# Safety Inspection Report

## Ty Isaf Play Area

Llanharry Community Council

09 June 2022

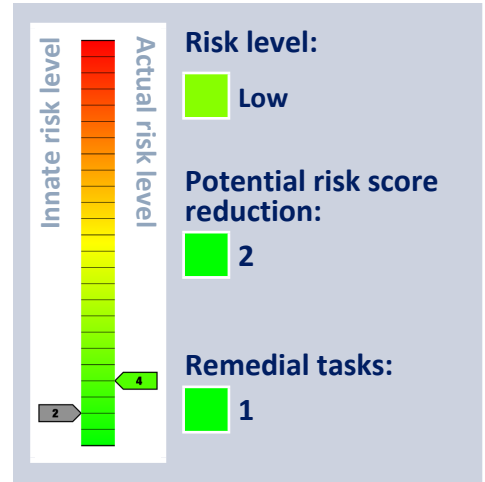
Trip points on the surface.

Make level.

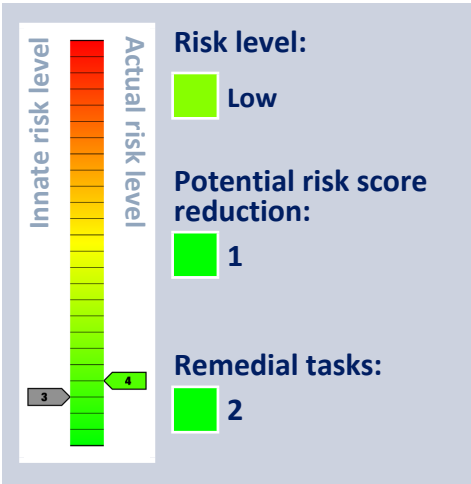
Description
Surface has holes in it.
Tasks
Repair.

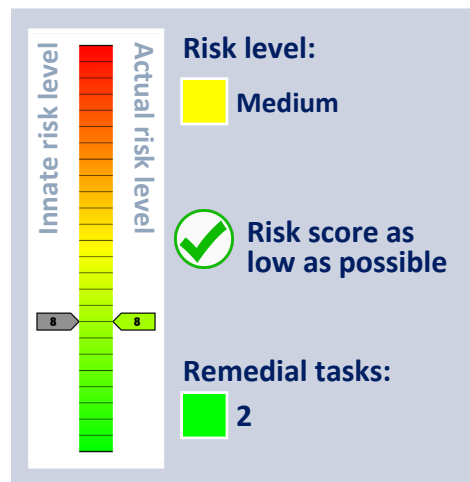
A warning notice should be fitted to all sports related equipment with the words "do not climb on the framework or nets", "do not hang on the ring" (if provided) and "do not wear rings or other jewellery as these can get caught and cause injury".

Fit warning notice.

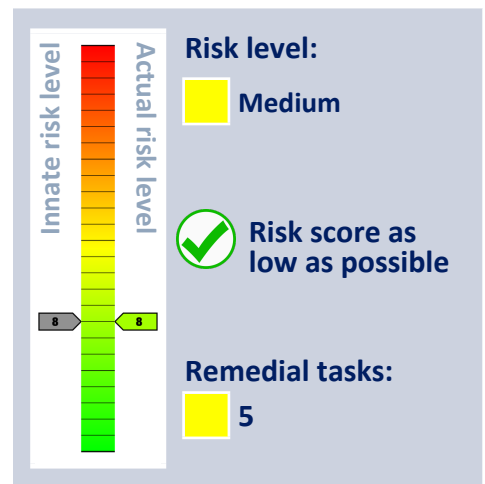
Item has corrosion.

Treat and repair.

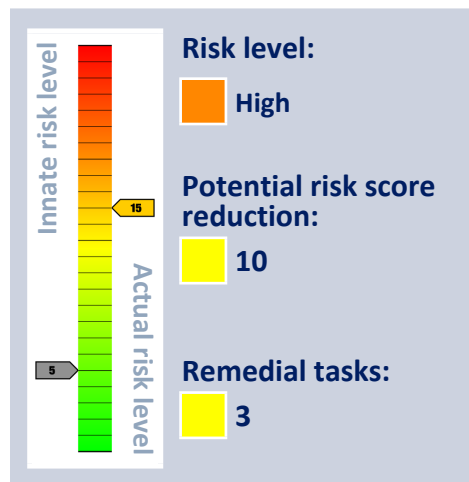
Mole hills present.

Eliminate.

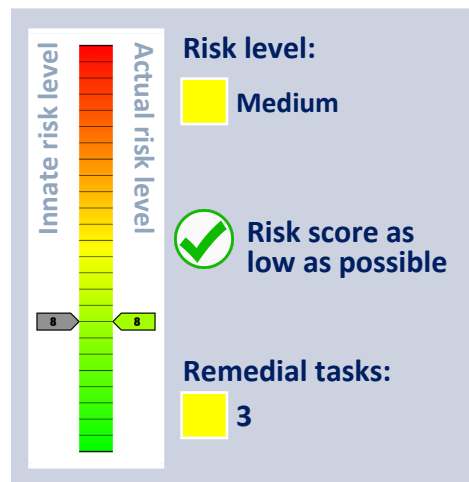
The wet pour surface is separating at the joints.

Monitor.

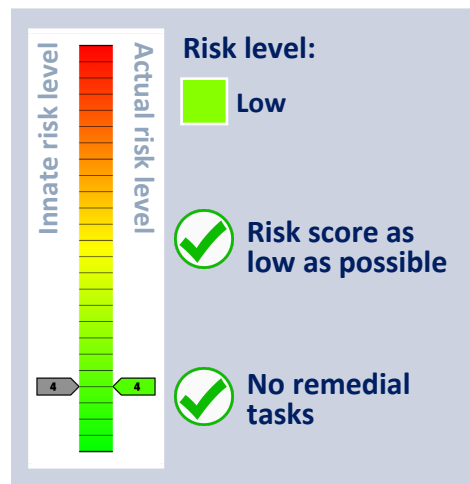
Seat(s) set at incorrect height.

Set to give minimum 400 mm ground clearance through full arc of motion.

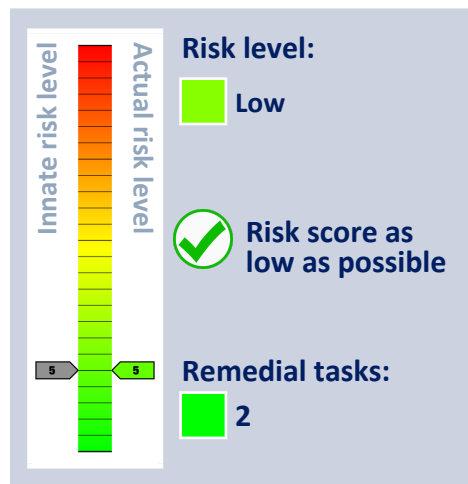
The wet pour surface is separating at the joints.

Monitor.

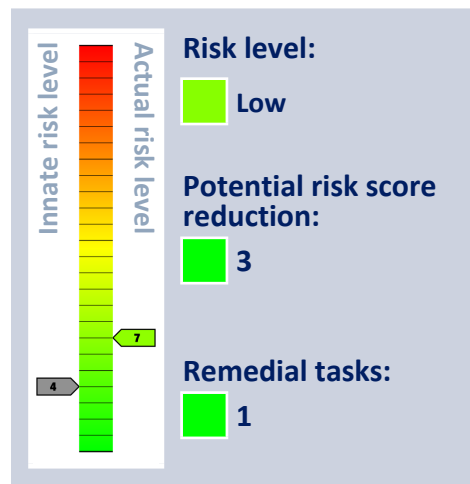
Shrinkage / separation of the surface. This may give a trip hazard.

Repair.

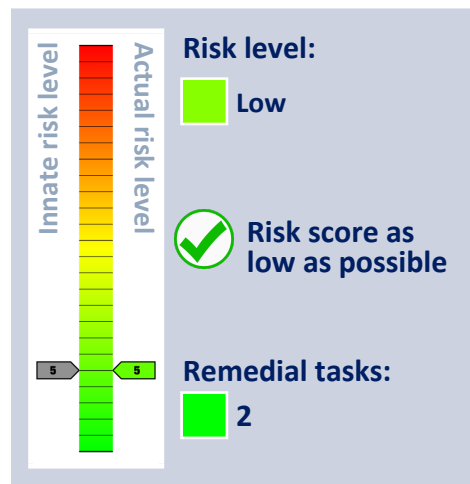
There is wear in the bushes.

Remove shackle bolt and check bush and shackle pin wear, replacing as necessary.
